AMENDMENT 1  
AMENDEMENT 1

Low-voltage fuses – **STANDARD PREVIEW**  
Part 6: Supplementary requirements for fuse-links for the protection of solar  
photovoltaic energy systems  
(standards.iteh.ai)

**Low-voltage fuses –** **STANDARD PREVIEW**  
**Part 6: Supplementary requirements for fuse-links for the protection of solar photovoltaic energy systems**  
(standards.iteh.ai)

This amendment has been prepared by subcommittee 32B: Low-voltage fuses, of IEC technical committee 32: Fuses.

**Figure 101 – Current of test cycling**

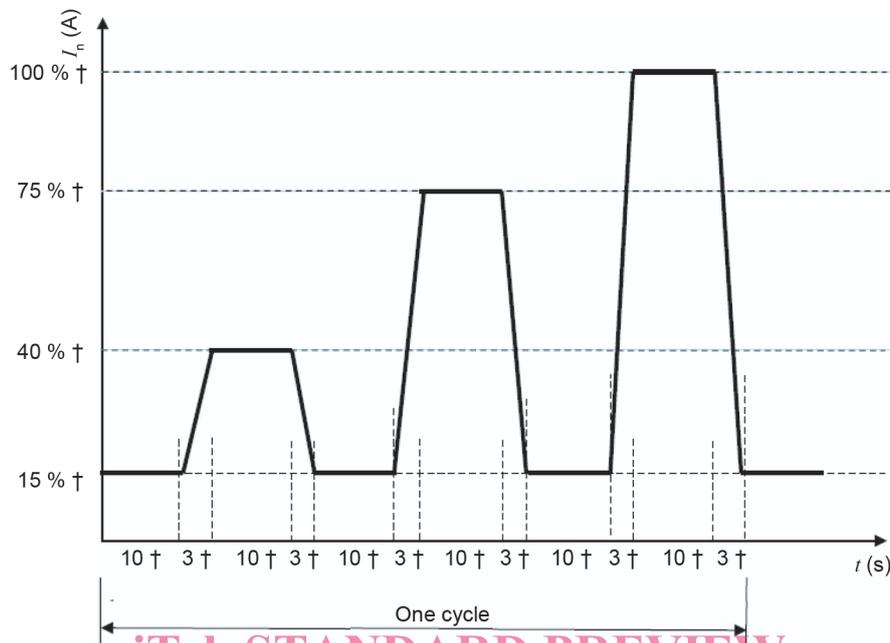
Replace existing Figure 101 with the following new Figure 101:

**iTeh STANDARD PREVIEW**  
 (standards.iteh.ai)  
 † Current: 100 % =  $(100 \begin{smallmatrix} 0 \\ -5 \end{smallmatrix})\%$  Time 10 s =  $(10 \begin{smallmatrix} +2 \\ 0 \end{smallmatrix})\text{s}$   
 75 % =  $(75 \begin{smallmatrix} 0 \\ -5 \end{smallmatrix})\%$  3 s =  $(3 \begin{smallmatrix} 0 \\ -3 \end{smallmatrix})\text{s}$   
 40 % =  $(40 \begin{smallmatrix} 0 \\ 5 \end{smallmatrix})\%$   
 15 % =  $(15 \begin{smallmatrix} 0 \\ -5 \end{smallmatrix})\%$   
 IEC 60269-6:2010/AMD1:2021  
<https://standards.iteh.ai/catalog/standards/sist/06c3ca19-122d-4052-bdfe-f001ce046f0f/iec-60269-6-2010-amd1-2021> IEC

**Figure AA.4 – Fuse-links with blade contacts, type C, C referring IEC 60269-2 "Fuse system A (NH fuse system)"**

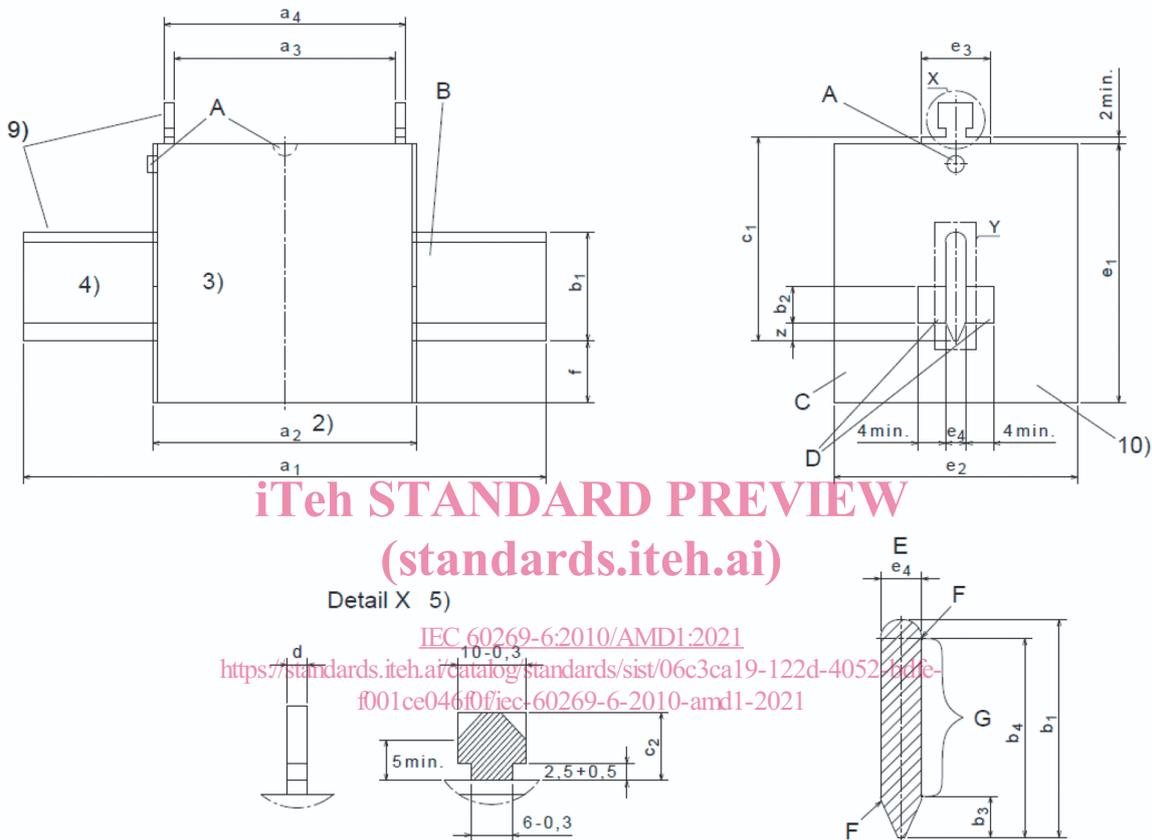
Replace existing Figure AA.4 with the following new Figure AA.4:
